Access Compliance Report

Public Rights-of-Way

Intersection ID: 5175	Main Street: FROSTMOOR_PL	Cross Street: HAYBRIDGE_RD	Location: NE
ADA ID: FF7CF6F44FE4	Ramp Type: PerpDiag	Initial Pass/Fail: Fail	Overall Compliance: No
		Severity Score: 8.75

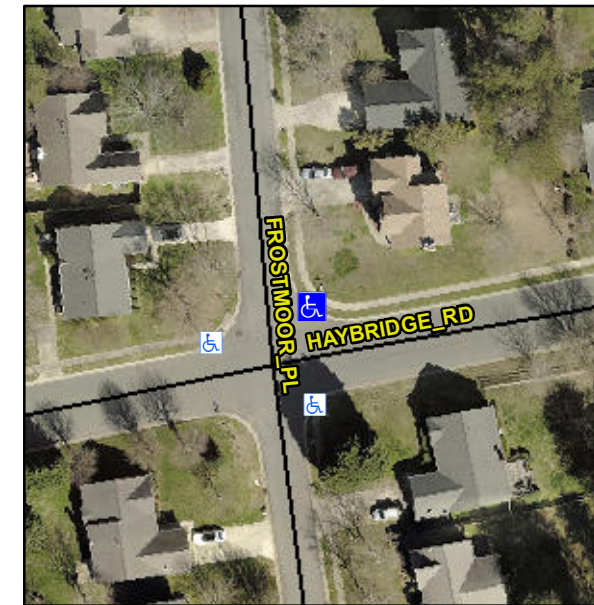
Not Found, R304.5.1

Compliance	Description	Data	Compliance	Description	Data
N/A	Ramp Length (in)	48.0	Yes	Ramp Slope (%)	5.1
No	Ramp Width (in)	47.0	Yes	Ramp XSlope (%)	1.4
N/A	Flare Type LT	N/A	N/A	Flare Type RT	N/A
N/A	Flare Slope LT (%)	N/A	N/A	Flare Slope RT (%)	N/A
N/A	Flare Traversable LT?	N/A	N/A	Flare Traversable RT?	N/A
N/A	Landing Length (in)	N/A	N/A	DWS Provided?	N/A
N/A	Landing Width (in)	N/A	N/A	DWS Contrast?	N/A
N/A	Landing Slope (%)	N/A	N/A	DWS Length (in)	N/A
N/A	Landing X Slope (%)	N/A	N/A	DWS Full Width?	N/A
N/A	Landing Curb? (Y/N)	N/A	N/A	DWS Offset (in)	N/A
N/A	Shared Landing?	N/A			
N/A	Gutter Ponding?	N/A	N/A	Gutter Slope (%)	N/A
N/A	Gutter Lip Ht (in)	N/A	N/A	Gutter X Slope (%)	N/A
N/A	Painted X Walk1?	No	N/A	Painted X Walk2?	No
	X Walk 1 Direction	To W		X Walk 2 Direction	To S
N/A	X Walk 1 Width (in)	N/A	N/A	X Walk 2 Width (in)	N/A
	X Walk 1 Slope (%)	5.5		X Walk 2 Slope (%)	4.0
	X Walk 1 X Slope (%)	2.3		X Walk 2 X Slope (%)	4.6

Remove & Replace Curb Ramp With Two New Directional Ramps or Equivalent.
